#### ADDENDUM NO. 7

**June 6, 2022**

# LIBERTY INTERMEDIATE SCHOOL ADDITIONS AND RENOVATIONS

This Addendum consists of Pages ADD 7-1 through ADD 7-4 and attached Addendum No. 7 from Gibraltar Design dated June 6, 2022 and consisting of 5 pages and 75 drawings.

© GIBRALTAR DESIGN SHEET MV102

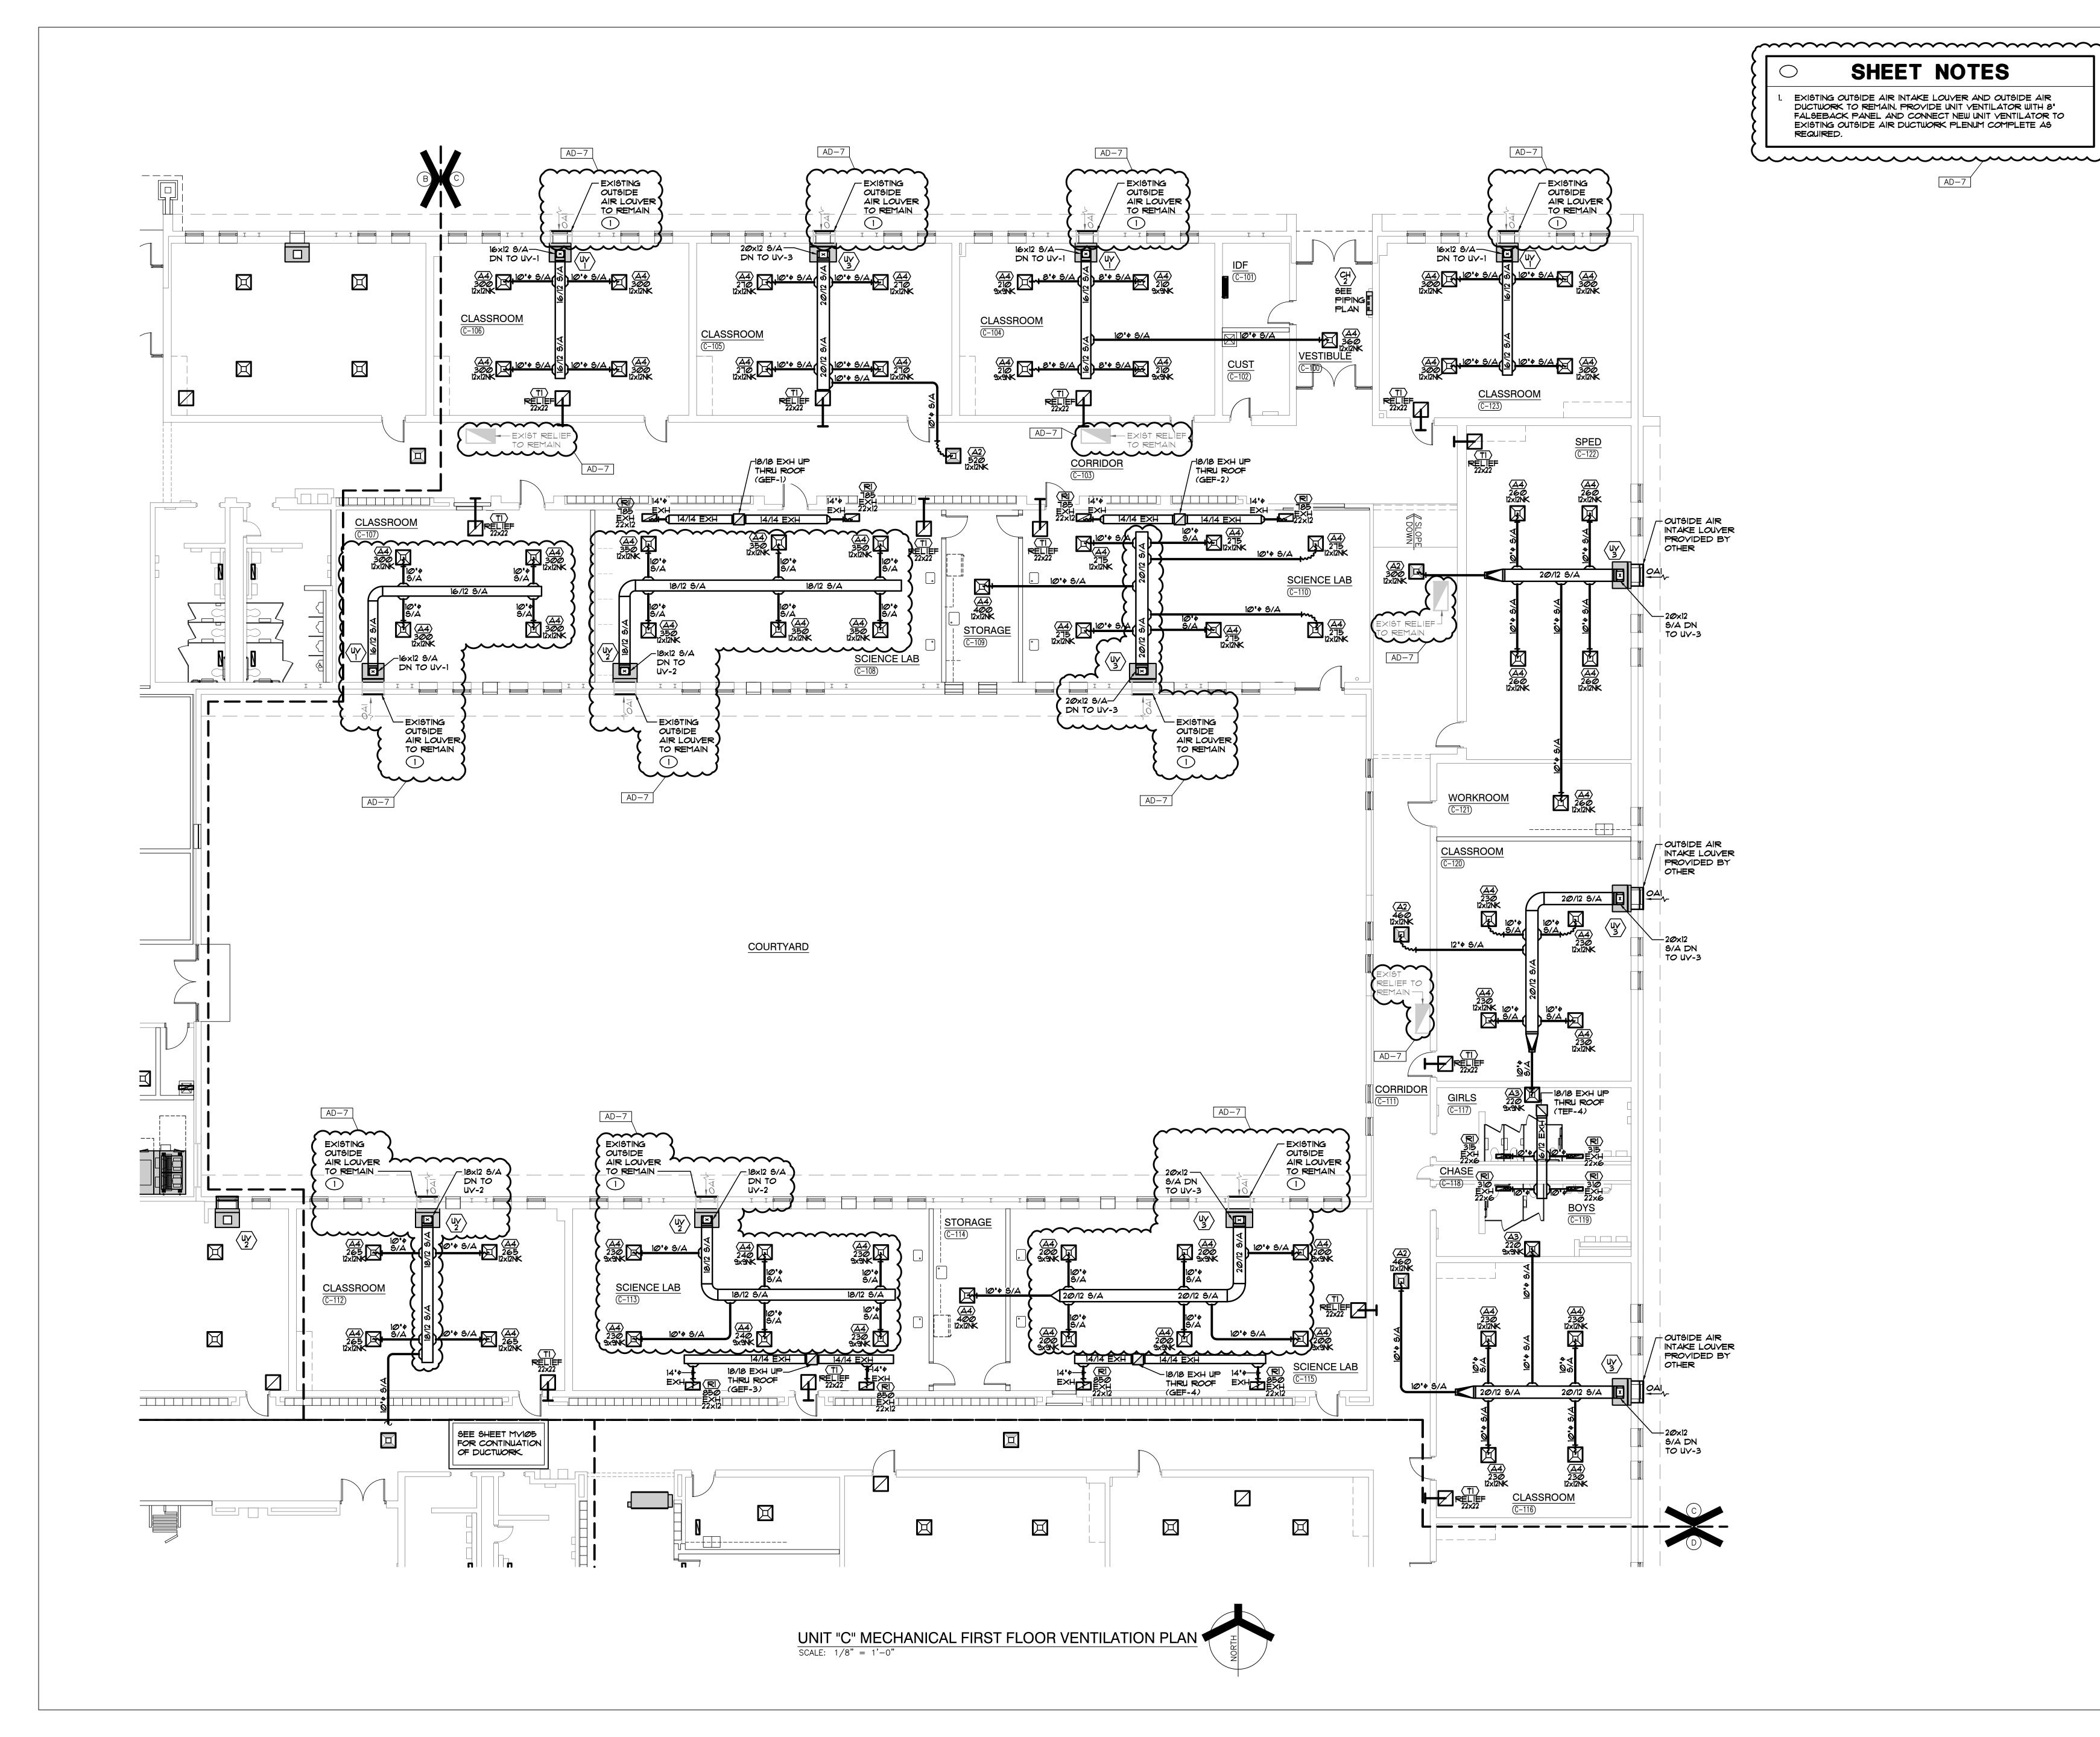
- A. Refer to revised full-size drawing included in this Addendum, for the following revisions:
  - 1. Added sheet note.
  - 2. Revised location and ductwork of unit vent.
  - 3. Revised louver existing to remain.

MV103

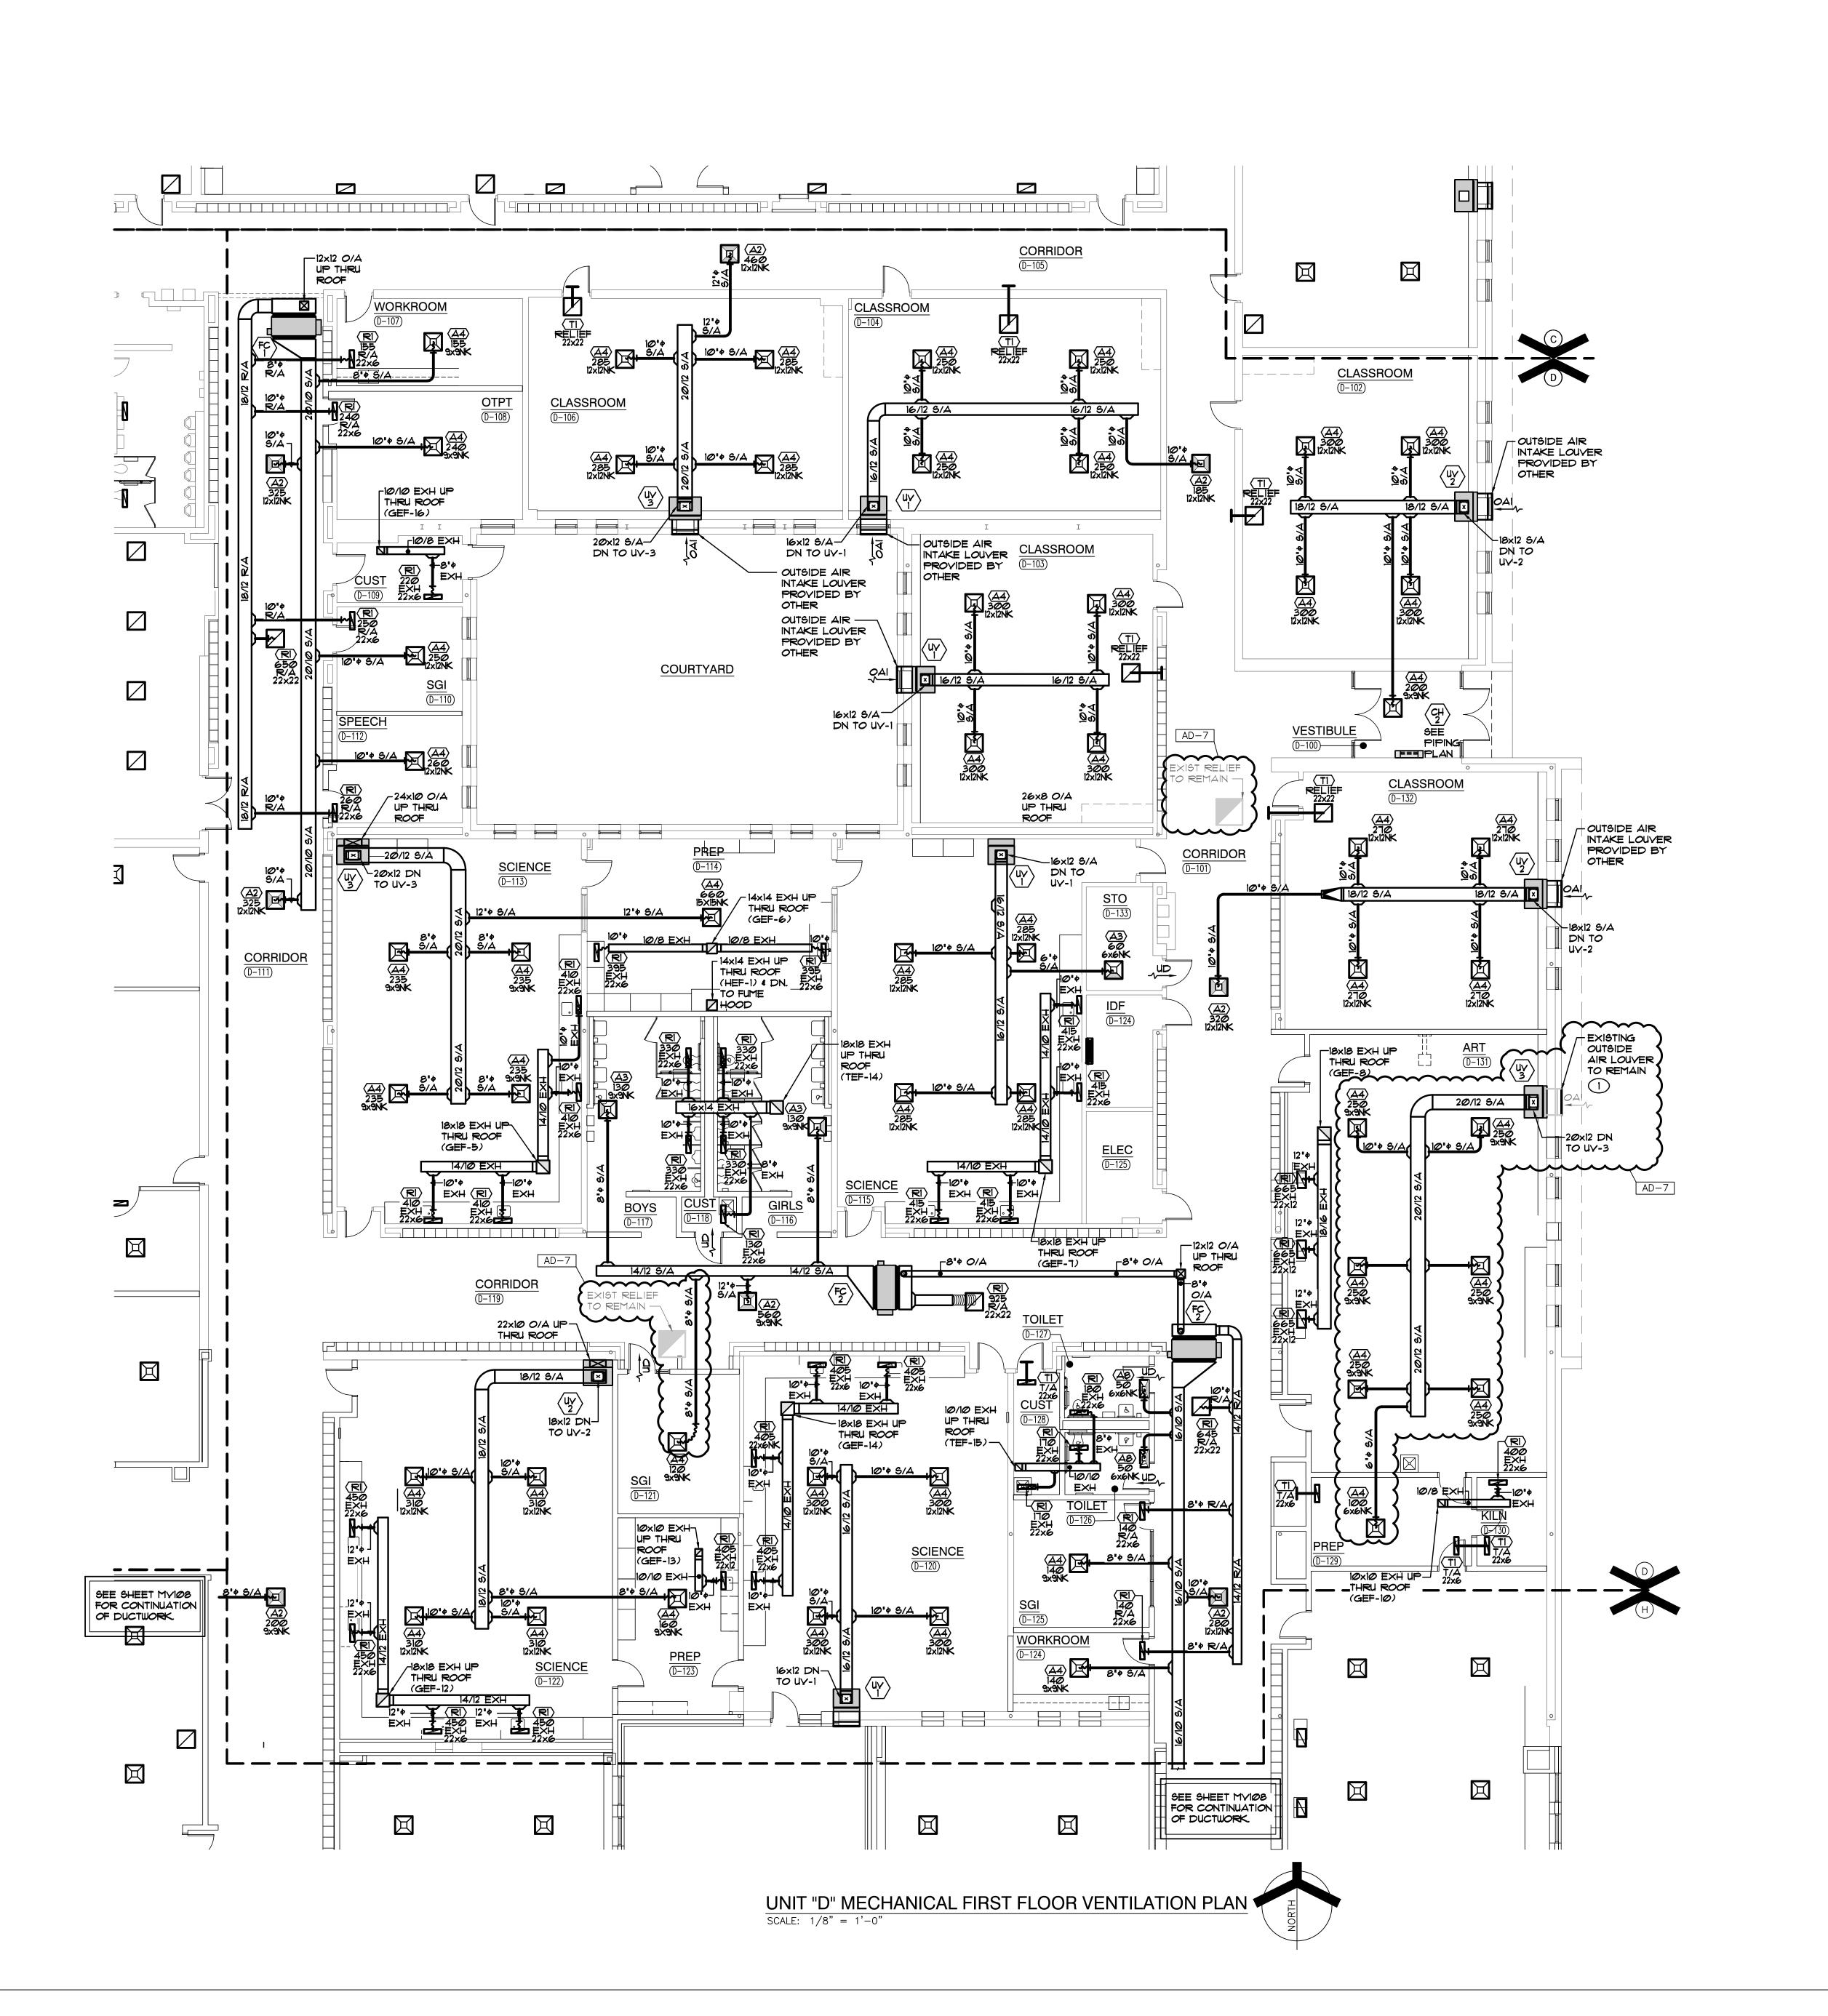
- A. Refer to revised full-size drawing included in this Addendum, for the following revisions:
  - 1. Added sheet note.
  - 2. Revised location and ductwork of unit vent.
  - 3. Revised louver existing to remain.
  - 4. Added existing relief air to remain.

MV104

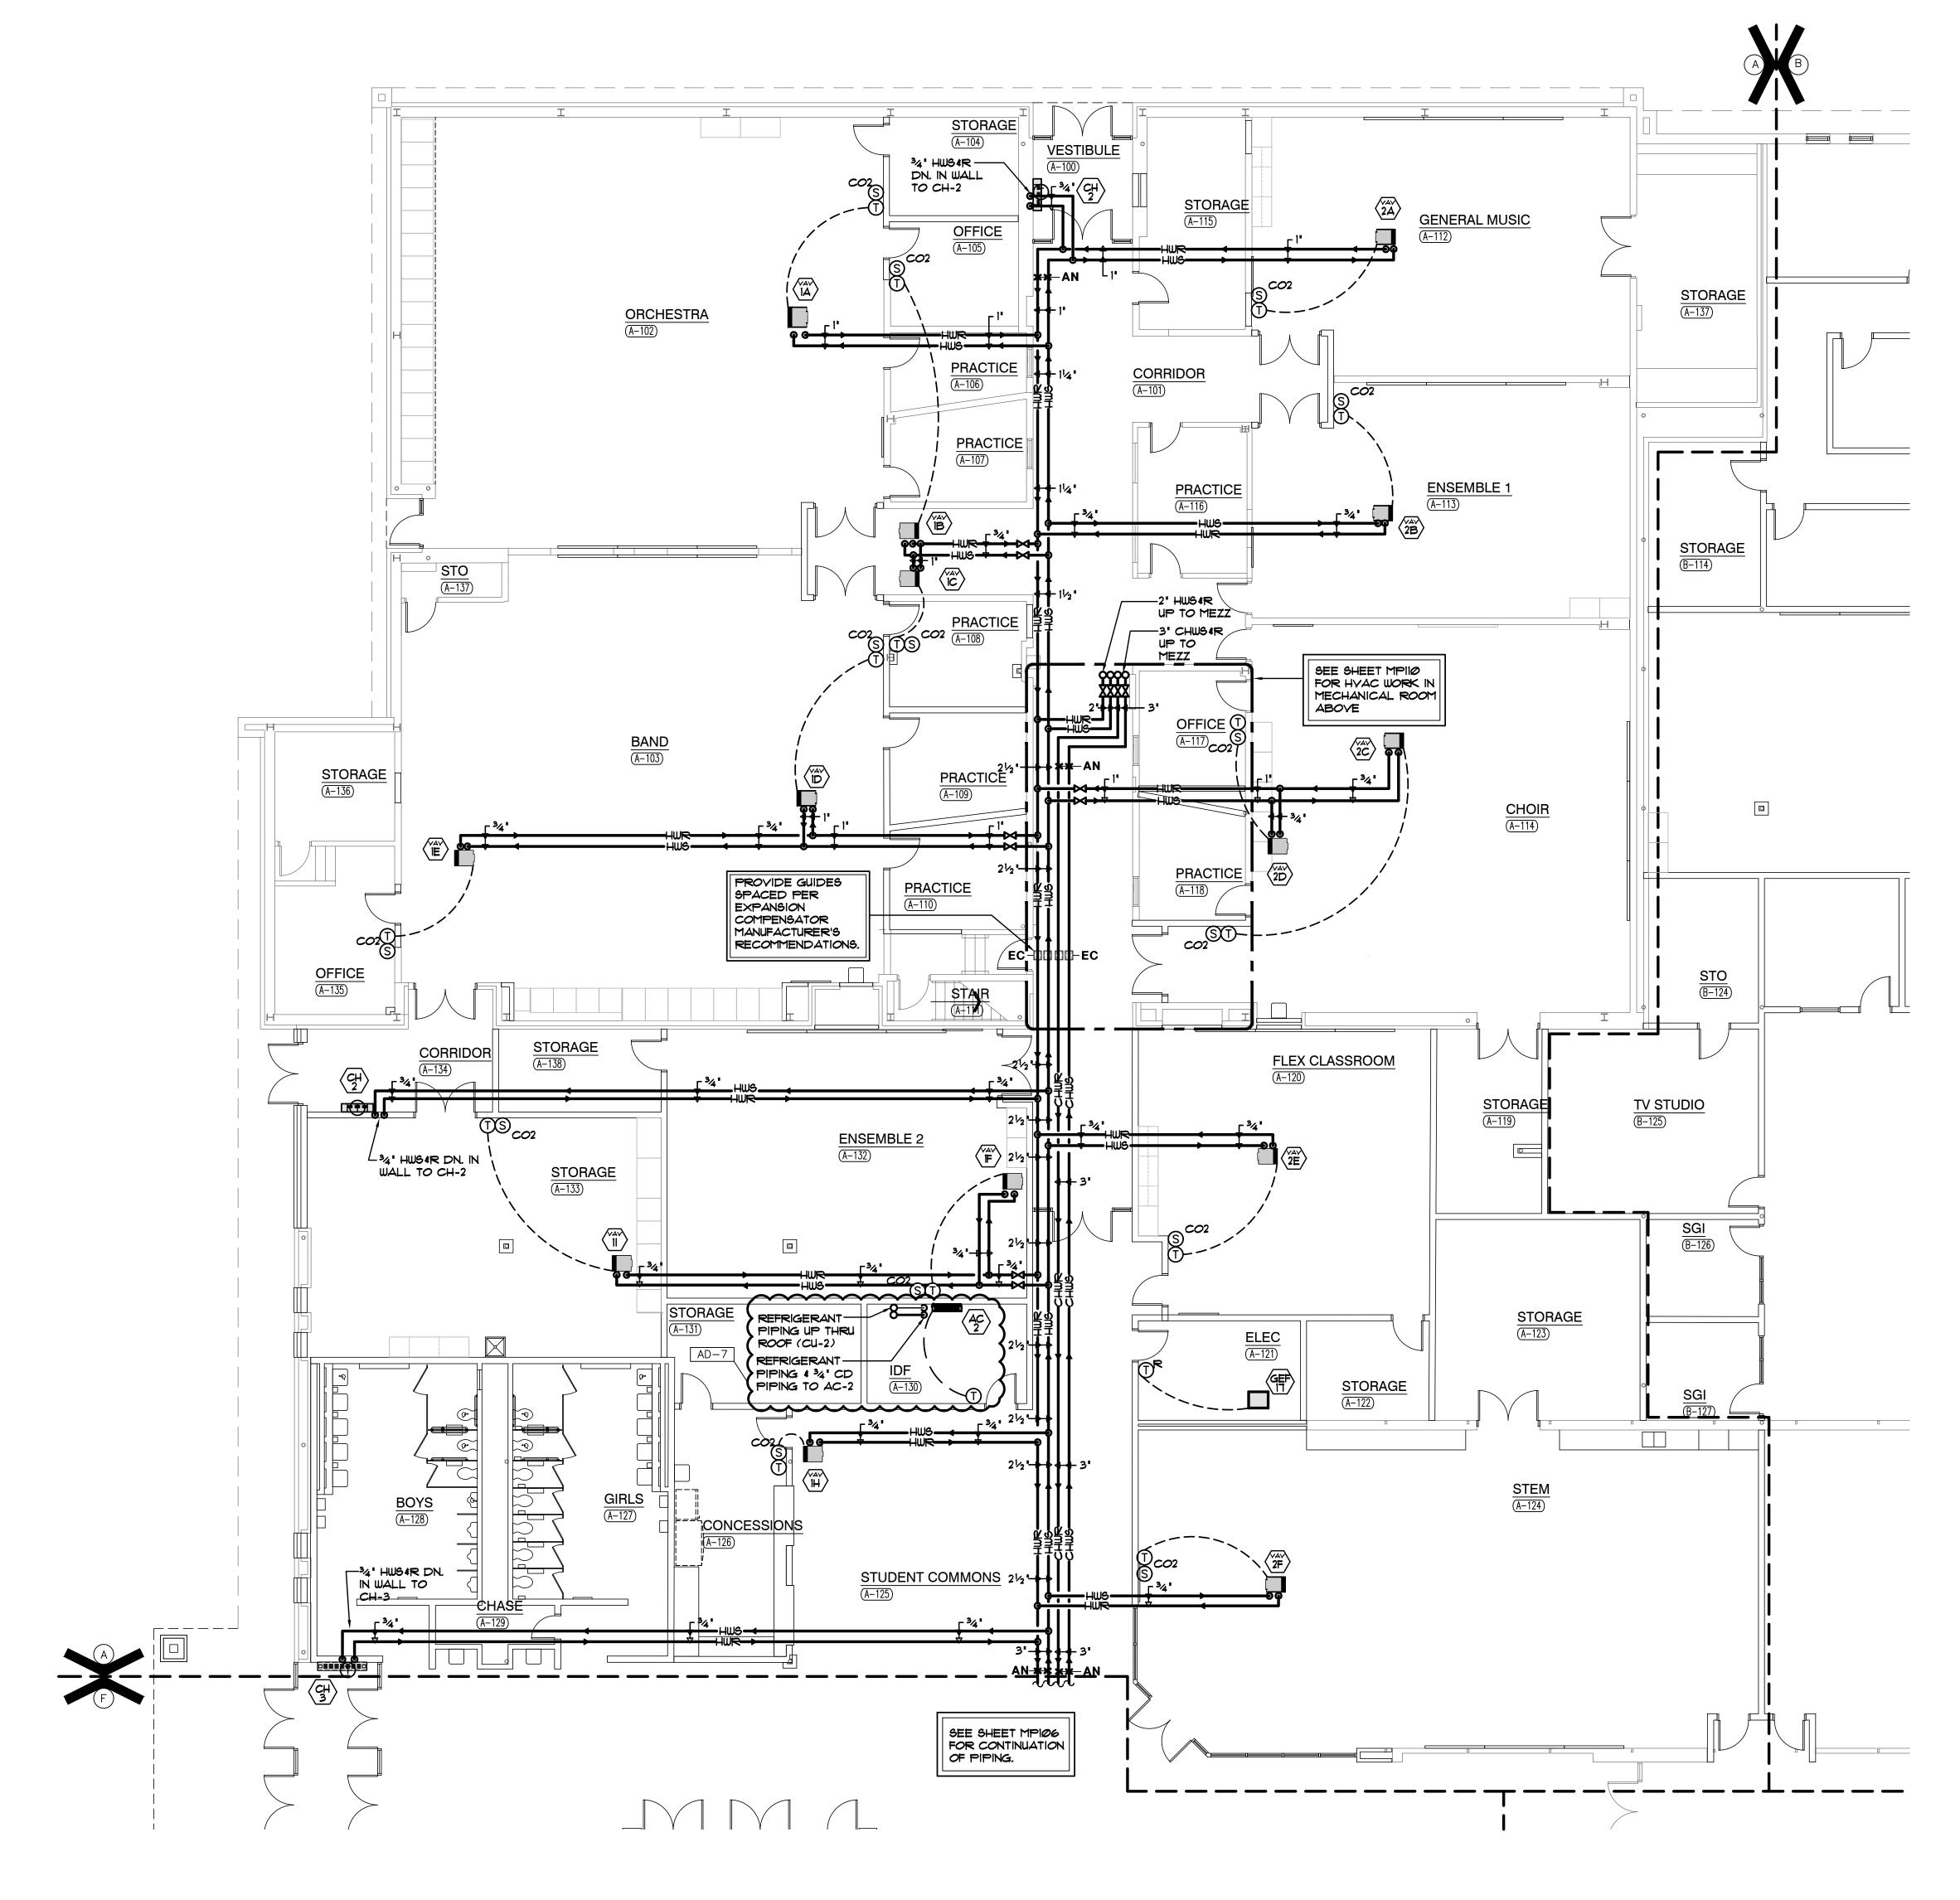
- A. Refer to revised full-size drawing included in this Addendum, for the following revisions:
  - 1. Added sheet note.
  - 2. Revised location and ductwork of unit vent.
  - 3. Revised louver to existing to remain.
  - 4. Added existing relief air to remain.
